NOTE TO THE USER

Due to a specification change, the tip enclosure for the Hakko MG is now welded with a copper grounding wire. Those users who have the old tip enclosure may replace it by the following procedure.

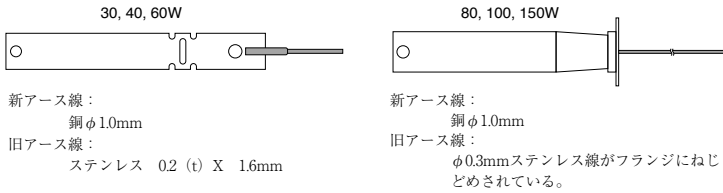
仕様変更により、新しいMGの保護パイプはアース用銅線が溶接されています。旧保護パイプをお持ちの方は次の手順で交換してください。

- ハウジングをとめているねじをはずし、ハウジングを開けます。
- 電源コードのアース線と旧保護パイプのアース線のはんだ付による接続をカバーしているガラスチューブをずらし、はんだ付部を露出させます。このチューブをなくさないでください。
- はんだ付をはずします。
- 旧の保護パイプをはずします。80、100、150Wはφ0.3mmのアース用ステンレス線を取り除きます。
- アース用銅線が上にくる様に新しい保護パイプを置きます。(こて先とヒーター用とめねじが正しい位置になっているかを確認ください。)
- 電源コードのアース線をアース線銅線にまきつけます。
- アース線をはんだ付けします。
- ガラスチューブを元の位置に戻します。
- 逆の順序で組み立てます。

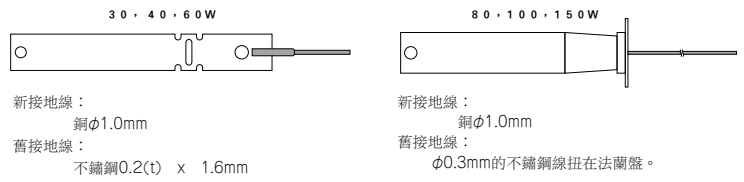
由于规格更改・新Hakko MG的发热元件罩罩已改用铜线與接地線溶接。用舊型發熱元件護罩的顧客請按照下列程序更換發熱元件護罩。

- 拆下鎖住外殼的螺釘。
- 移出保護電源線的接地線和舊型發熱元件護罩的接地線之間的焊接部之玻璃管。小心勿丟失其玻璃管。
- 解開焊接部分。
- 取下舊型發熱元件護罩，然後也將80・100及150W的接地線用的鑄銅線取下。
- 將接地線用的銅線朝向上的放在新發熱元件護罩上。(確認焊鐵頭及發熱元件用的螺釘位置是否正確。)
- 將電源線的接地線纏上接地銅線。
- 焊接接地線。
- 將玻璃管放回原來的位置。
- 組裝成原樣。按照拆開步驟裝回原裝。
